Subject: Palo Verde Nuclear Generating Station  
Unit 1  
Docket No. STN 50-528 (License No. NPF-41)  
NRC Request for Additional Information on the  
January 9, 1986, Reactor Trip at PVNGS Unit 1  
File: 86-E-056-026

## ATTACHMENT

### RESPONSES TO NRC QUESTIONS

FIGURE 1

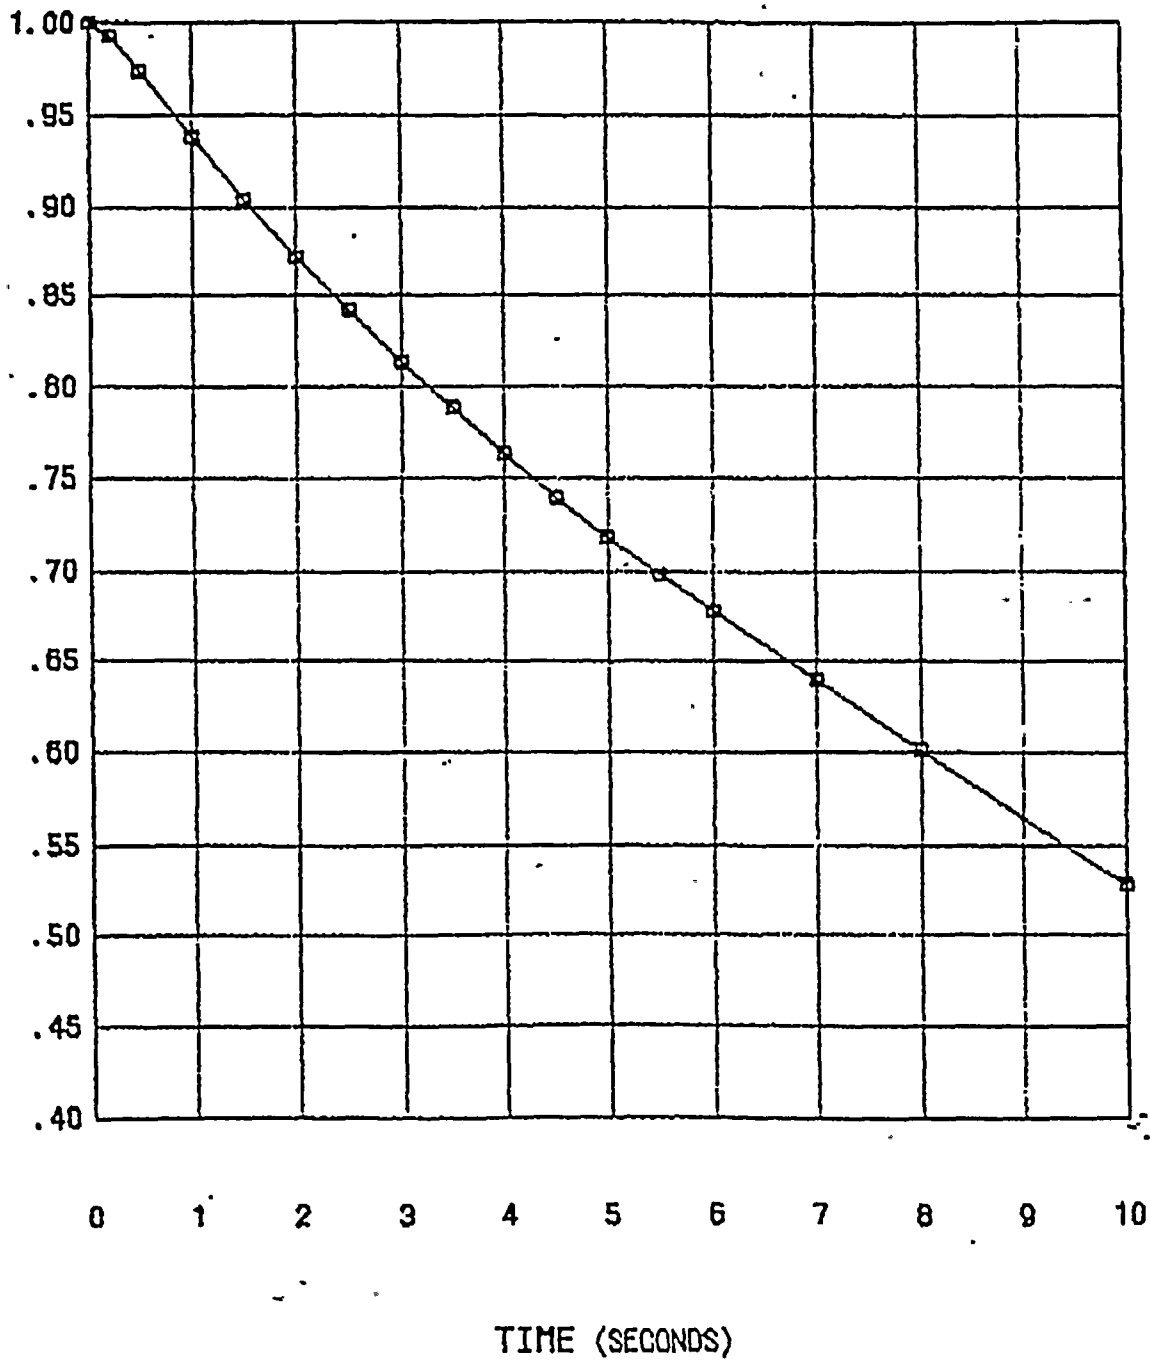
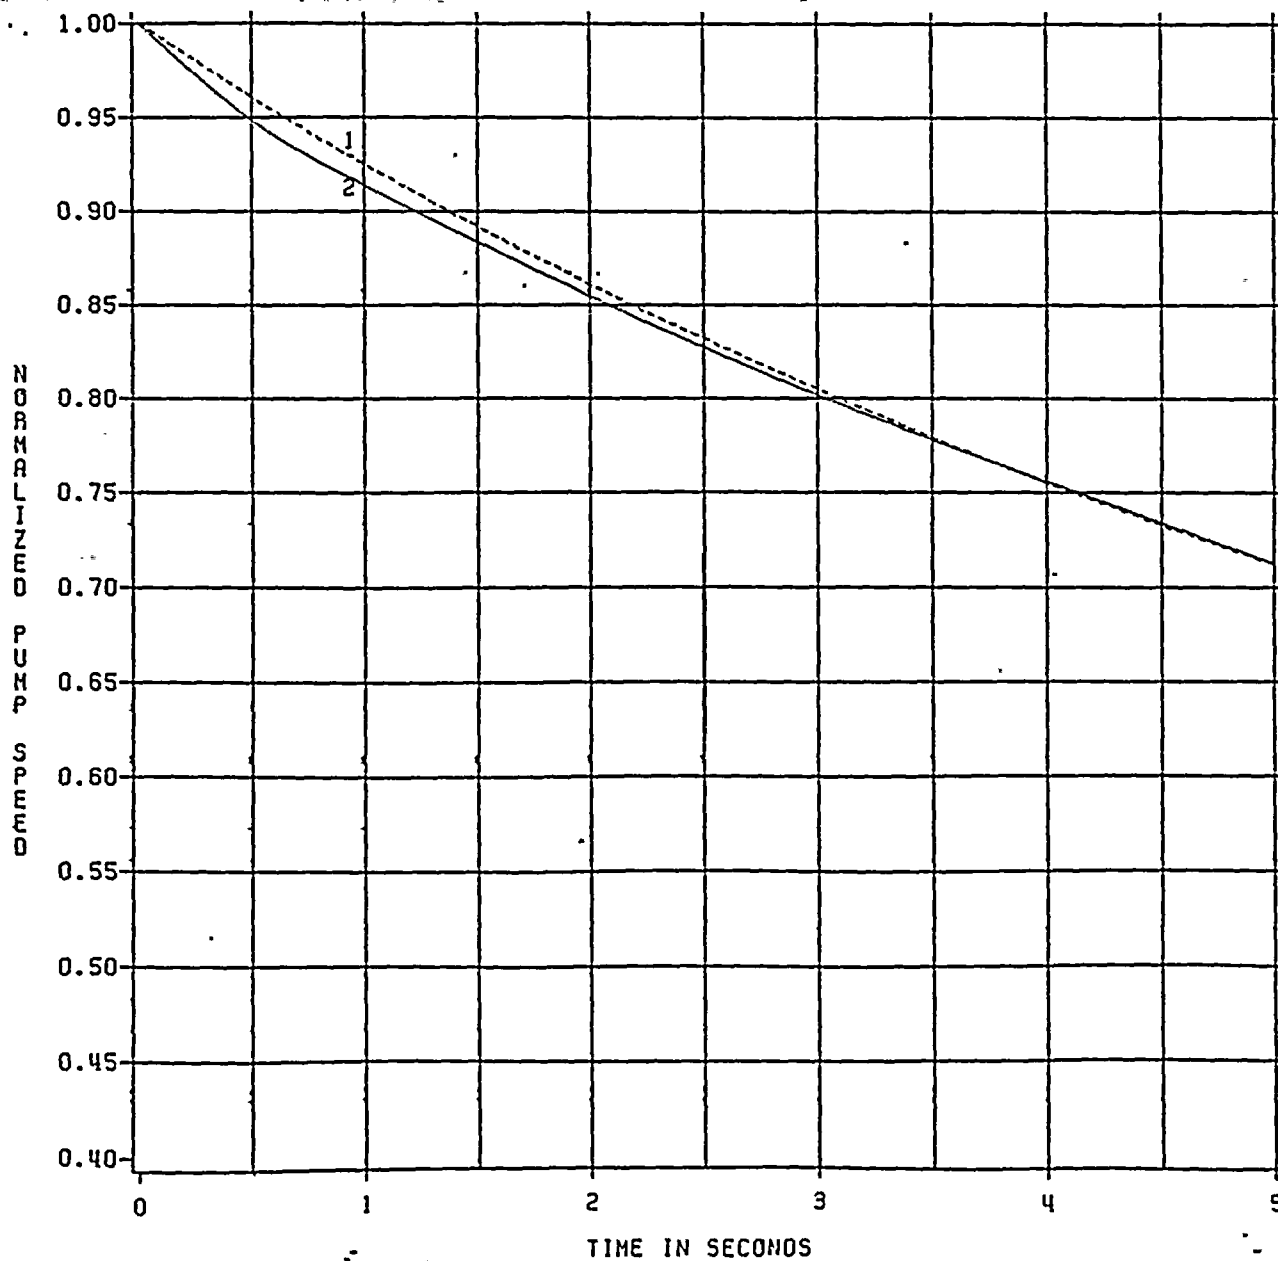
1. NRC QUESTION: What is the coastdown rate of the RCPs assumed in the FSAR and what are the factors or assumptions on which this value is based?

ANPP RESPONSE: Two different Reactor Coolant Pump (RCP) coastdown rates are used in the safety analyses for PVNGS. Figure 1 of this attachment shows the assumed RCP flow coastdown utilized for the total loss of reactor coolant flow accident analysis (refer to CESSAR Section 15.3.1). This flow coastdown curve used for the total loss of reactor coolant flow accident analysis is a best estimate curve based on how the RCPs were expected to perform in the coastdown mode. The total loss of reactor coolant flow accident analysis is the only PVNGS accident analysis that uses the best estimate flow coastdown curve. For any of the other PVNGS accident analyses, the assumed RCP coastdown is conservatively fast since only 90 percent of the RCP rotational inertia is assumed. This equates to a conservatism in the coastdown flow rates which varies from about 1 percent faster coastdown at 1 second into the coastdown to about 5 percent faster coastdown at 10 seconds. Thus, the only accident analysis which was potentially affected by the faster than expected coastdown rate was the total loss of reactor coolant flow analysis.
